MEMORANDUM

SUBJECT: Five-Year Review for the Selma Pressure Treating Superfund Site, Selma CA

Five-Year Review Report

USACE OMAHA DISTRICT RAPID RESPONSE OFFUTT AFB, NEBRASKA SELMA, CALIFORNIA
	Figure 3 APRIL 2000 SAMPLE RESULTS

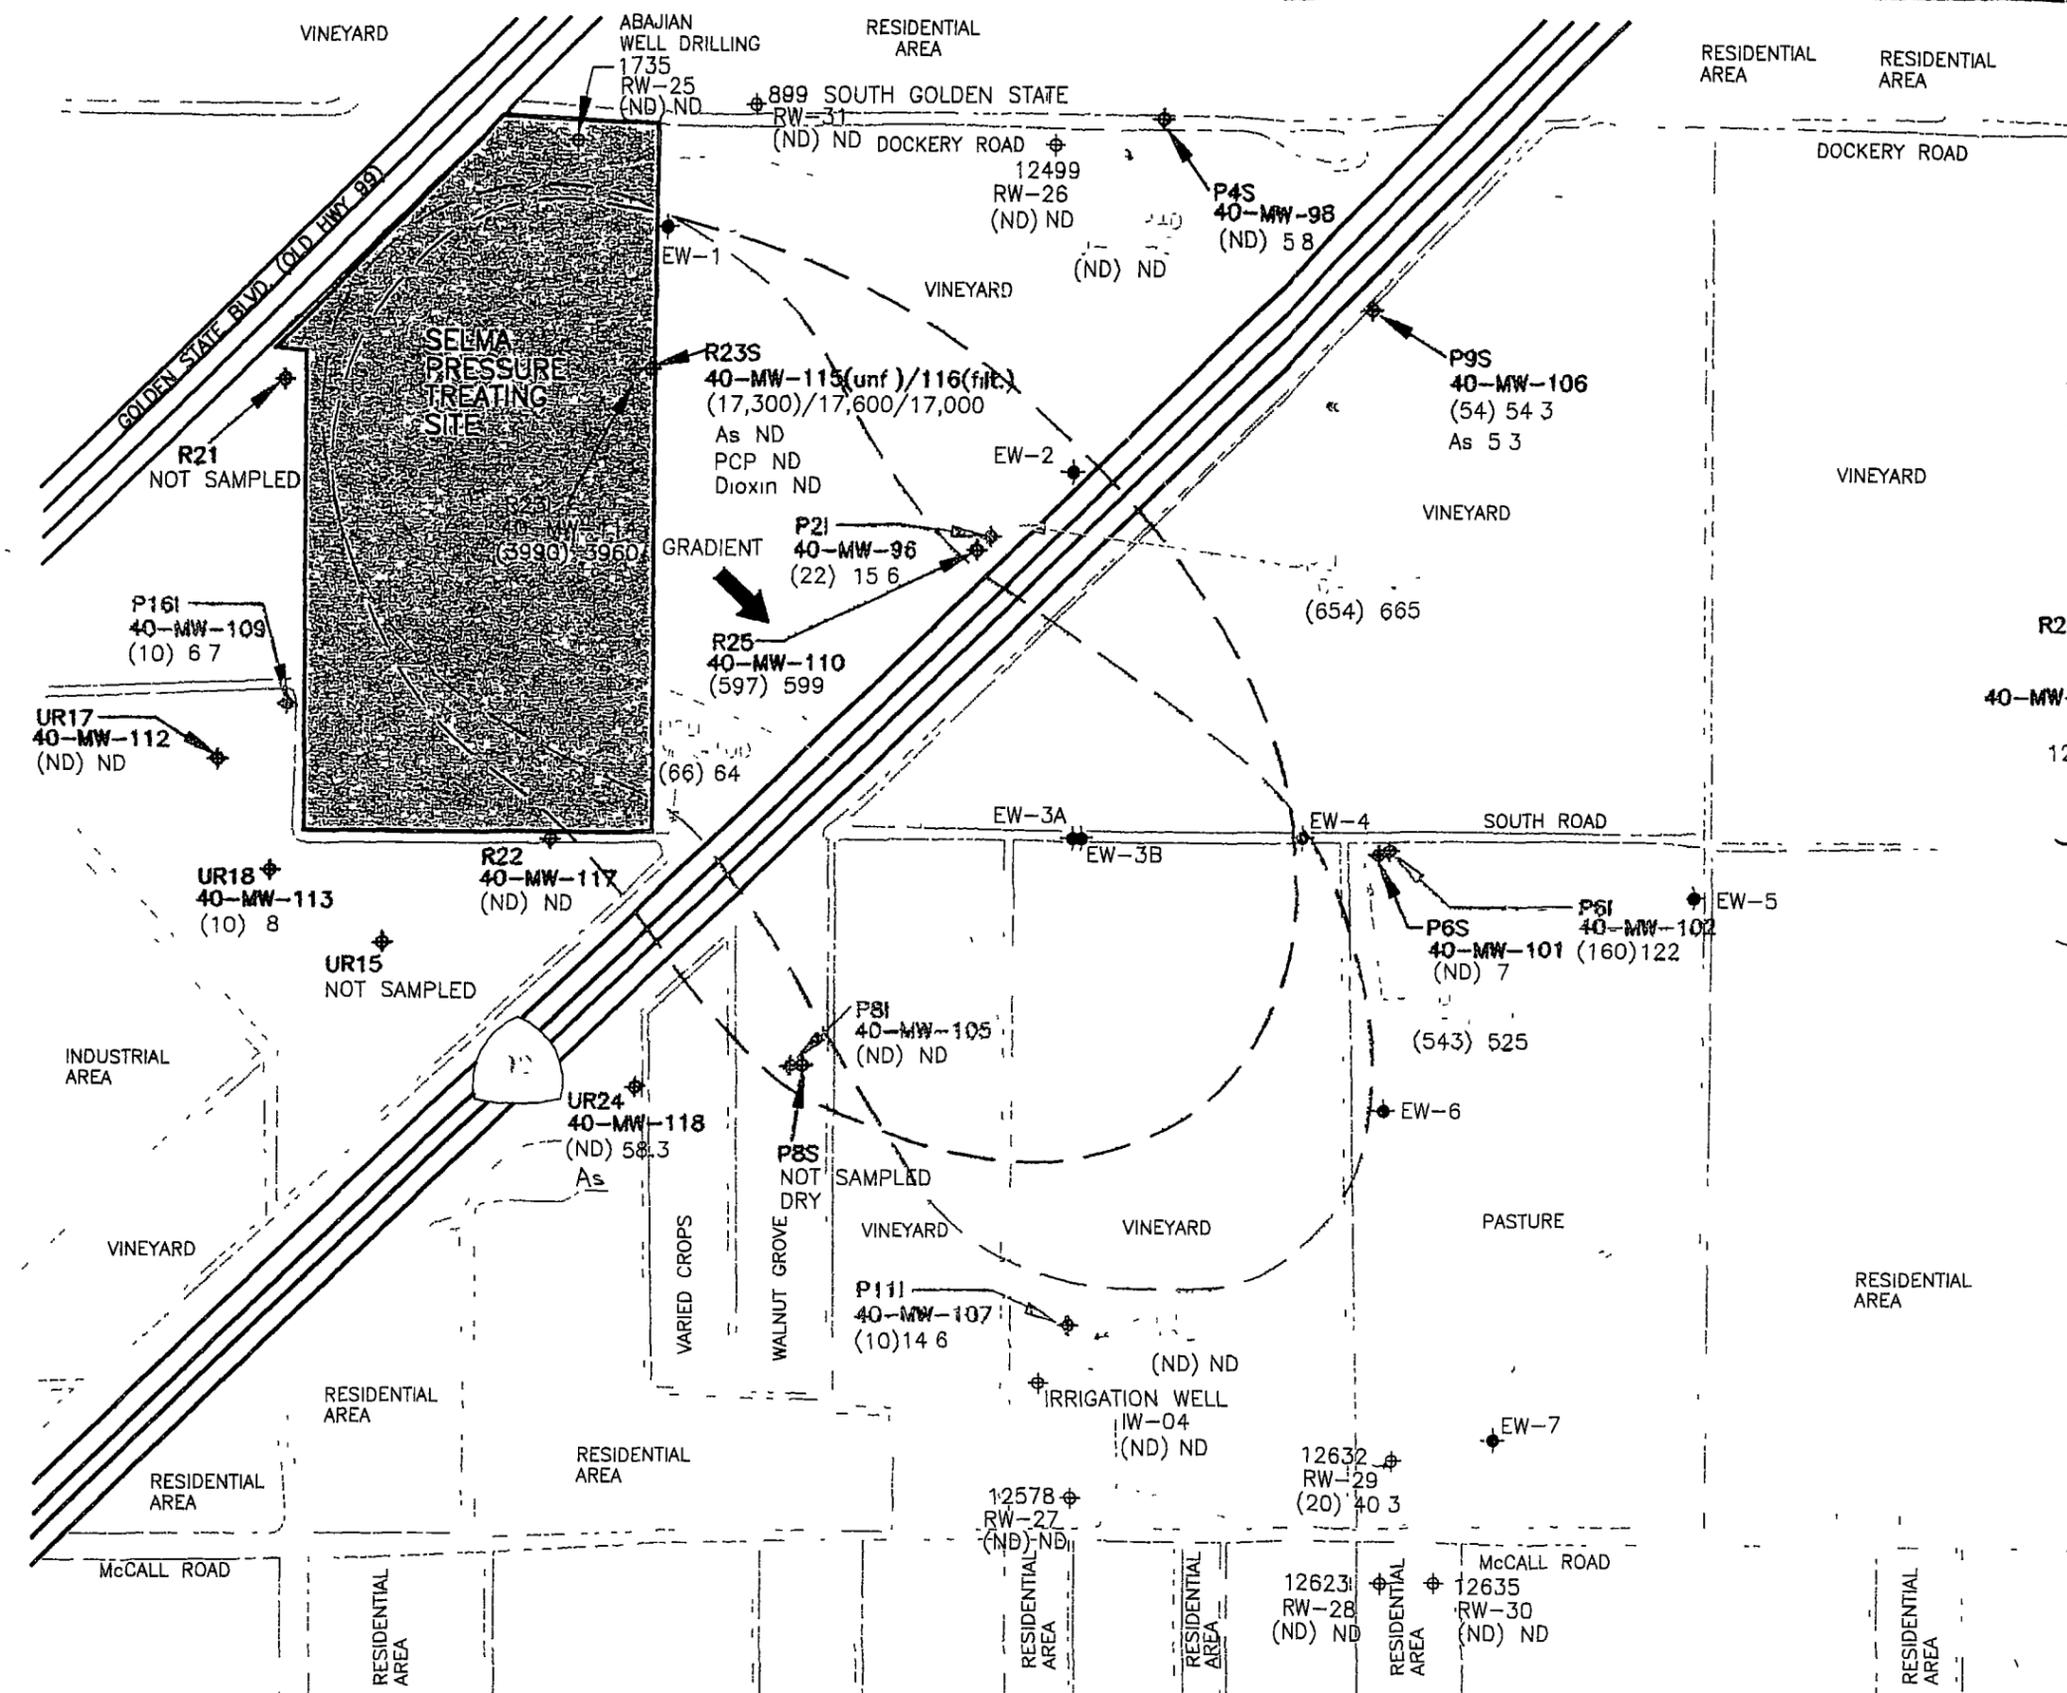
There are locations where shallow wells were dry in 1997 and could not be sampled. However, with a rise in the water table of between nine and ten feet between August 1997 and February 1999, these wells have been sampled on subsequent occasions. The April 2000 data are presented on Figure 3.

A review of data from intermediate and deep wells does not show the same decreasing trend in chromium concentrations. Concentrations of both hexavalent and total chromium have increased over time in wells P2D, P5D, P6I, P6D, and R23I. These data indicate that chromium affected groundwater is being drawn downwards.

Chromium concentrations in shallow monitoring wells P9S and UR24 are also increasing. These monitoring wells are located cross-gradient from the plume. These data indicate that the chromium plume is not contained in the cross-gradient direction. Additionally, there are no monitoring wells beyond these two points to define the lateral plume boundaries.

Groundwater monitoring data indicate that the chromium plume is not contained vertically or in the cross-gradient direction. There are inadequate control points (e.g., monitoring wells) at the plume boundaries to ascertain plume distribution and whether it is being contained. There are no criteria established to determine when groundwater cleanup is complete and when the groundwater extraction and treatment system can be turned off. These criteria need to be established.

Covered stockpile of affected soil

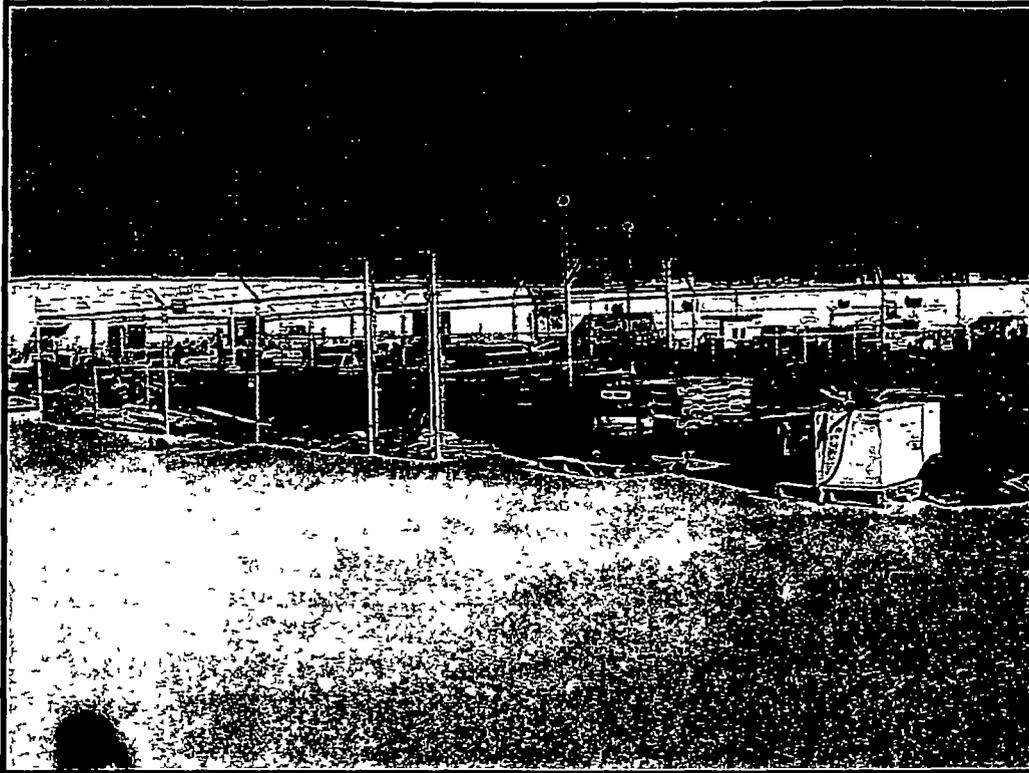
- The site is overgrown with weeds and there are empty drums and other debris at various locations,
- Two stockpiles of contaminated soil generated in September 1999 remain on-site These stockpiles are currently covered with seamed, plastic tarpaulins, secured around the edges with earth berms,
- Fencing is in good condition,
- One gate was left open on the day of the site inspection,
- Exclusion zones are taped off and signed,
- There are no Proposition 65 warnings posted, and
- There is no control of off-site drainage

- The stockpiles be incorporated into the final soil remediation solution (as currently proposed in the FFS),
- The potential for site run-off/run-on be investigated and control measures, if required, be implemented, and
- Locking caps be installed on all monitoring wells

Monitoring well 114 missing locking lid

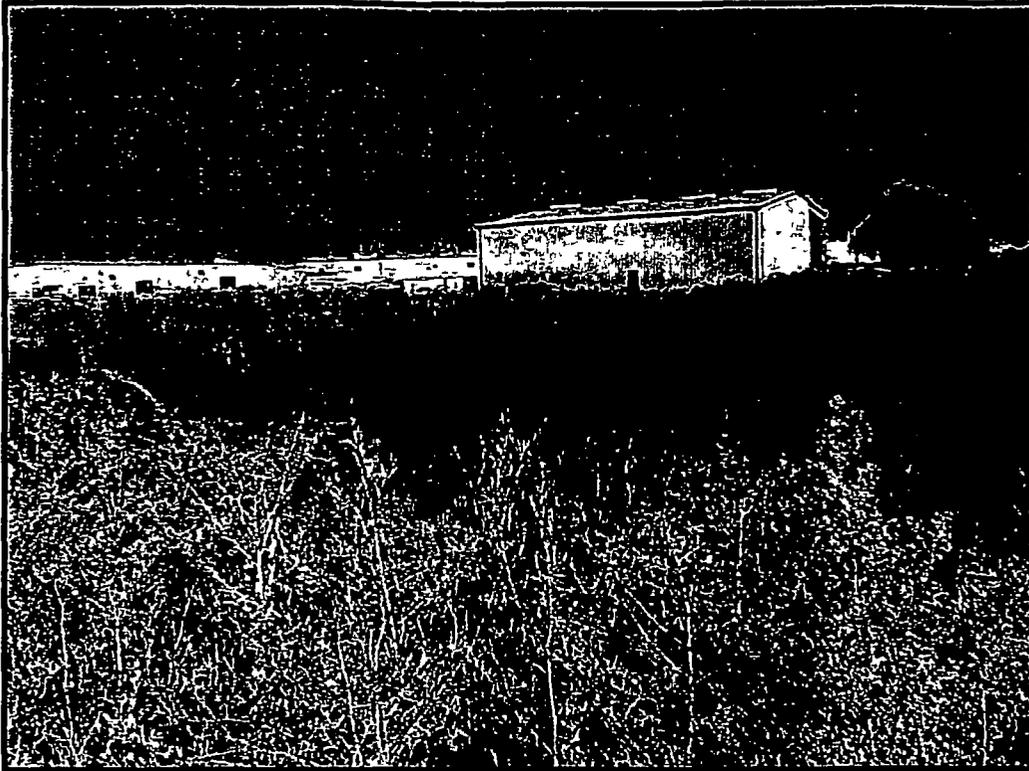
Monitoring well 110 in unsecured at grade vault

Monitoring well 115 with damaged casing and missing locking lid
